Subject: Re: Coastal Rail Trail Project Discussion

Thank you for forwarding Serge's comments and his proposal. After careful evaluation and thought, please see the points below in response:

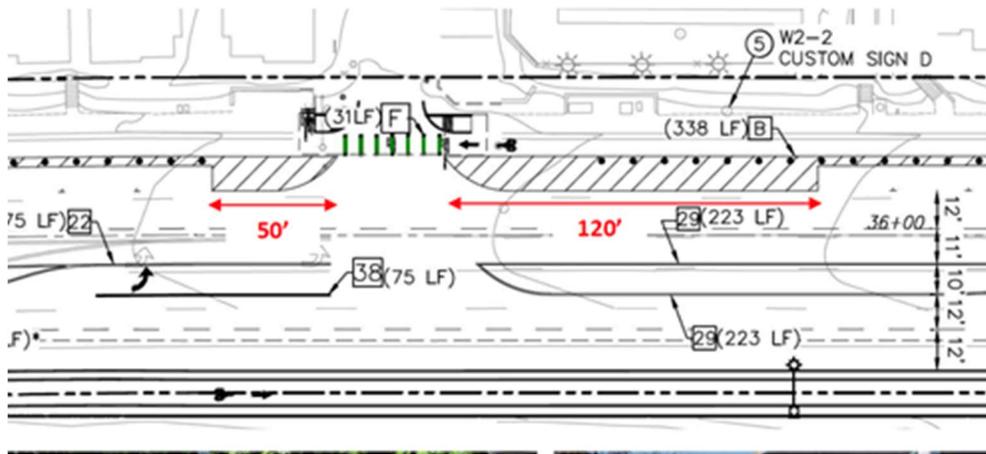
- The raised median is not proposed in areas where driveways or minor streets intersect the bike facility. As shown in the image below, the raised barrier (or allowed parallel parking) is terminated at least 120 feet north of the upcoming intersection and it is replaced by a painted median with flexible delineators with parking not allowed. The cycle track is also painted green and dashed at the crossing. This provides for increased visibility of cyclists and signage alerts drivers and cyclists of the upcoming crossing.
